Non-Conformance Report

Contract Name/No: RMA/2022/2524 NCR Ref No: 01
Country View Stage 2B

Please see attached updated landscape plans (Revision A4) alongside this NCR.

Drawing		Project Date	
Conceptual Landscape Plan		Oct 2023	
Project/Client		Scale @ A3	
Country View Stage 2 [RMA/2022/2524]		1:1000	
Suburban Estates Ltd		Purpose of Issue	
Job reference Drawing number		Approval	
23111-01-01		Revision	
		A4

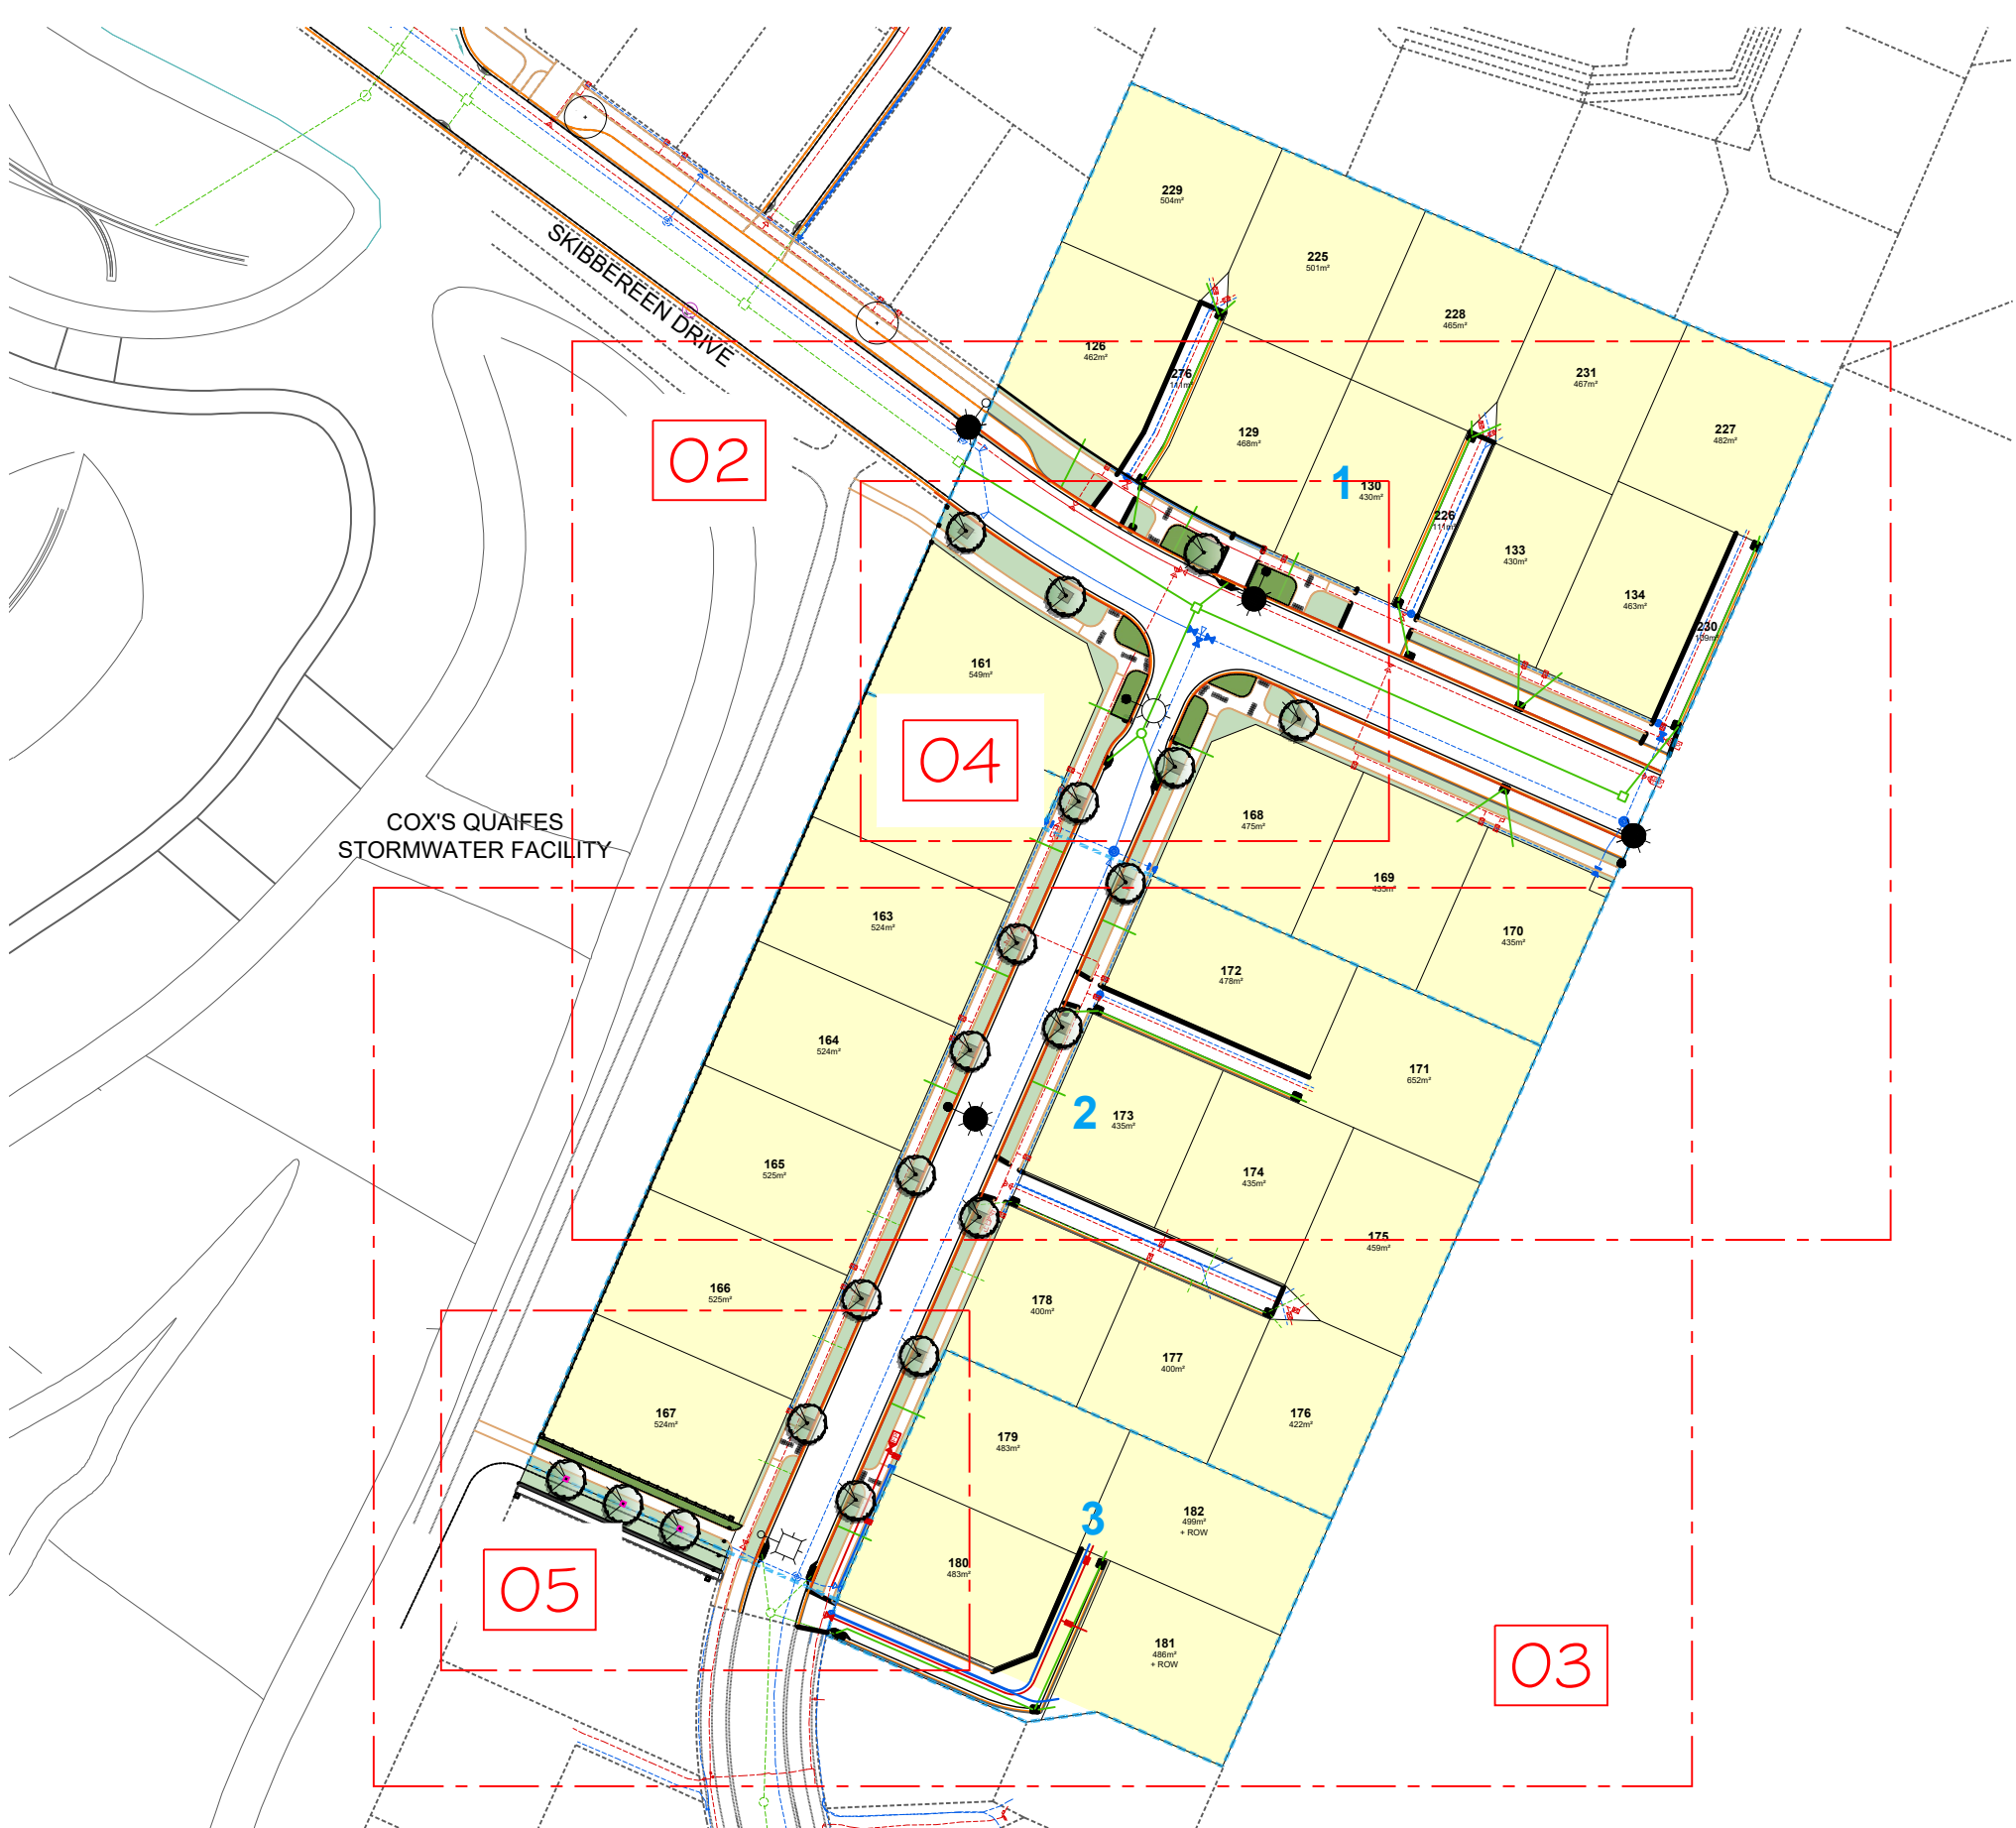
Now that the development of Stage 2B is underway, there are a few things that have been revised since the original landscape plans were approved.

1. Changes to pedestrian crossing location, and revised lot staging layout.
2. Unable to source acceptable Magnolia 'Gere' trees at this time.
3. Developed link reserve design, following completion of neighbouring development.

1. The layout of street trees within Stage 2B has been revised. Please see updated plans attached.
2. Magnolia 'Gere' was substituted with Magnolia 'Star Wars' (following consultation with the project arborist and CCC).

3. The design of the link reserve (Lot 600) has been revised to better fit with the neighbouring developments half of the reserve (including a secondary flow path, and differing levels), and to include trees. To accommodate trees within the narrow reserve, compromised offset requirements have been discussed with CCC and the project arborist. We are also proposing the use of 600mm dagmat squares (ex terra lana) instead of the standard bark mulch, as the trees are within the secondary flow path, the bark mulch may be washed away in a storm event. The dagmat squares will be installed to manufacturers specifications (including decomposable pins), and will be easily replaced during the maintenance period if they start to look untidy.
